ADDITIONAL INFORMATION ON GINNA
ROCK ANCHOR DESIGN

PREPARED FOR
ROCHESTER GAS & ELECTRIC CORP.

BY
GILBERT ASSOCIATES, INC.

FIGURE 1. POOR ORIGINAL

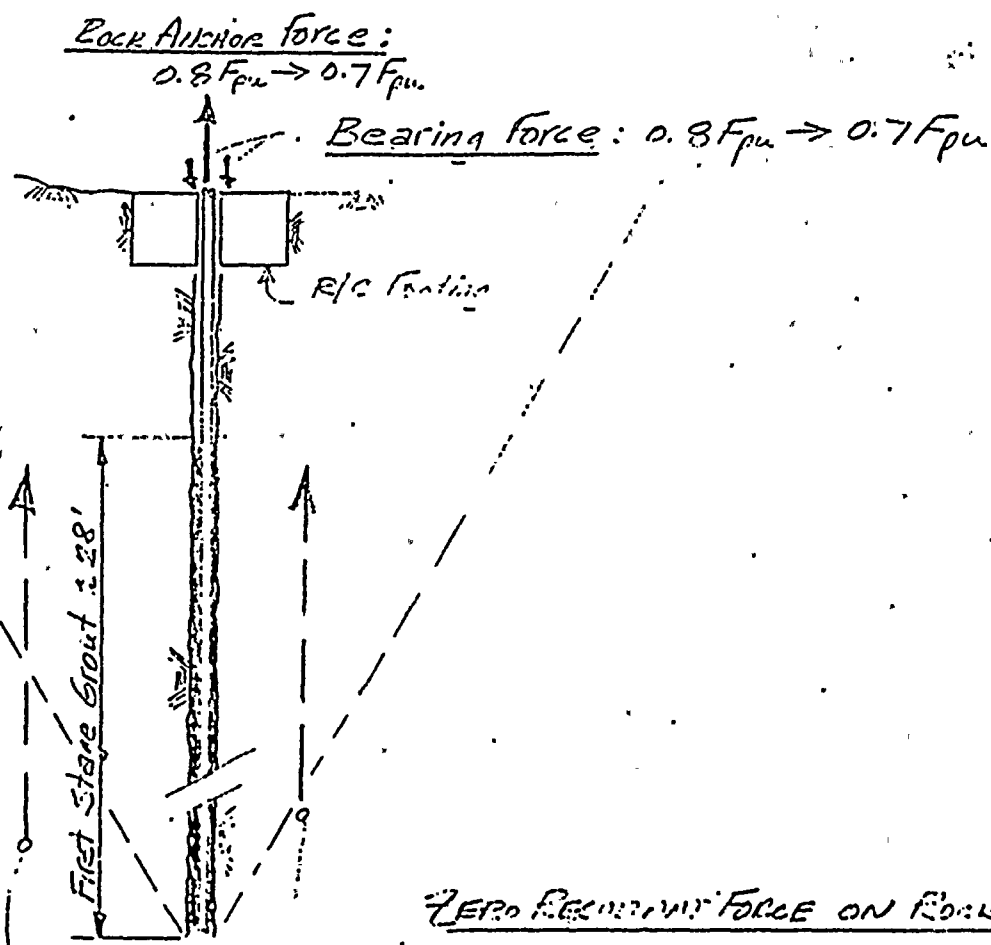
Except during containment pressurization, the resultant uplift force on the rock wedge surrounding the rock anchors is zero. As Figures 1 and 2 illustrate, the upward force which the rock anchor tendons exert on the rock (at the grout-rock interface) is always in equilibrium with a downward reaction force on the rock at the footing-rock interface. This equilibrium condition existed at the various stages of rock anchor stressing and wall tendon stressing, and it is not changed by the lift off tests of the past surveillances, nor by the recently completed retensioning program.

DETAIL FOR TENDON COUPLING

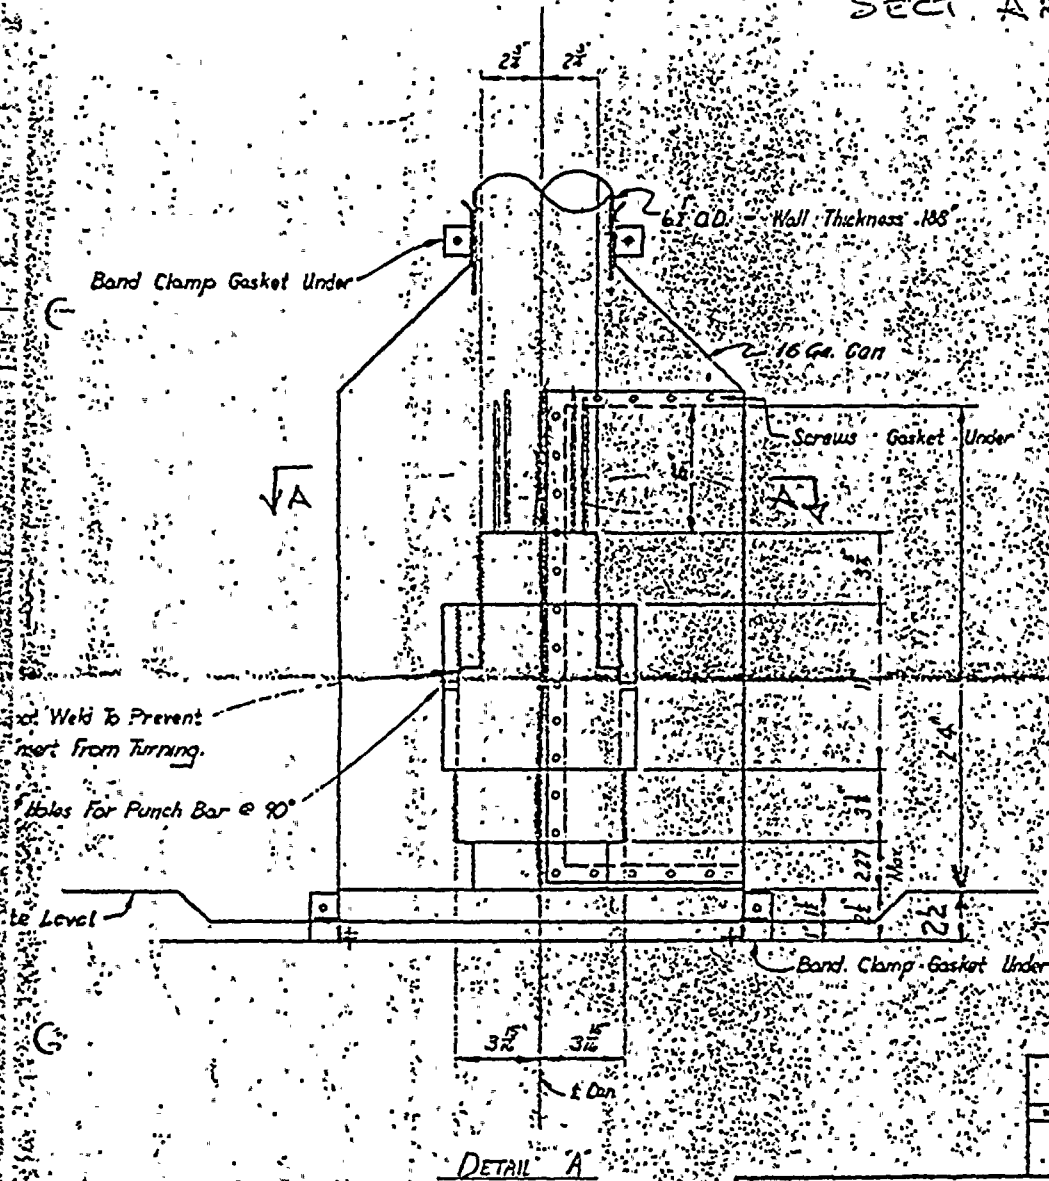
As Mr. Ted Brown is out of the office this week, I have taken the liberty of reviewing and commenting on drawing B-400-606-1 per your letter of July 13, 1966. Based on my discussions with Mr. Brown, the 2'-4" dimension should be to the top of the concrete, not the bottom of the bearing plate. Also the access cover on the coupling protection "can" should be attached to a turned up or welded on lip (see Sect. AA in red pencil) on the sides and as shown top and bottom.

I have made a copy of half of drawing B-400-606-1 and marked the above in red pencil. I am enclosing a copy of the present drawing of the coupler for your information.
